From: [Wolfenbarger, Jeanne](#)
To: ["jeffwooten.pe@gmail.com"](mailto:jeffwooten.pe@gmail.com)
Subject: K09-D038 Applebee's (Traffic Circulation Layout and Grading and Drainage Plan) Review
Date: Monday, April 06, 2015 4:38:09 PM
Importance: High

Applebee's
XXX 98TH STREET
ALBUQUERQUE, NEW MEXICO

Traffic Circulation Layout

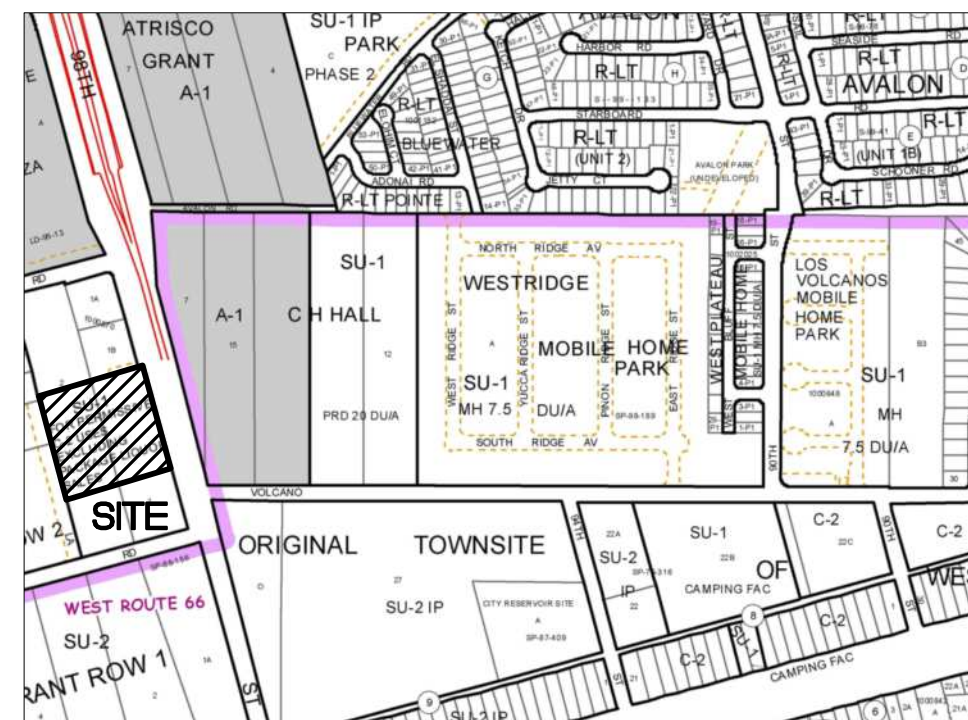
Regarding the Traffic Circulation Layout, you have addressed all comments with some minor exceptions:

1. We still need to show a truck delivery route for approval. This has been standard for our Traffic Circulation Layout reviews. Show how a truck can navigate through the parking lot with the necessary turning movements. You may show this informally on a separate sheet which is what a lot of people often do to avoid cluttering the site plan.
2. Call out Keyed Note 30 for both driving entrances for the clear site triangle. (On one of them, you show Keyed Note 35.)
3. Label 24' aisle on the north end just west of where you show the 40-foot easement to make it clear that 2-way traffic can navigate through the north aisle of the site.
